State of New Mexico  
Energy, Minerals and Natural Resources

Form C-103  
Revised July 18, 2013

# Proposed P+A

Duncan 32 State Com # 1

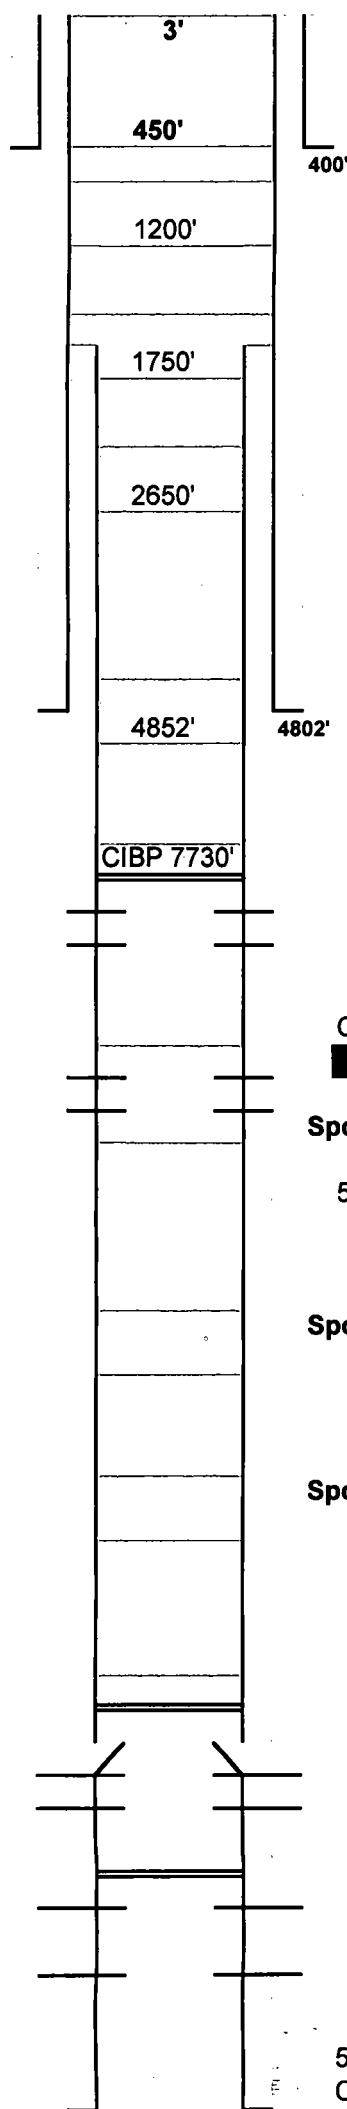
Plug # 1 - Set CIBP @ 7730' + 35' cement on top. **25 SX Class H CMT**
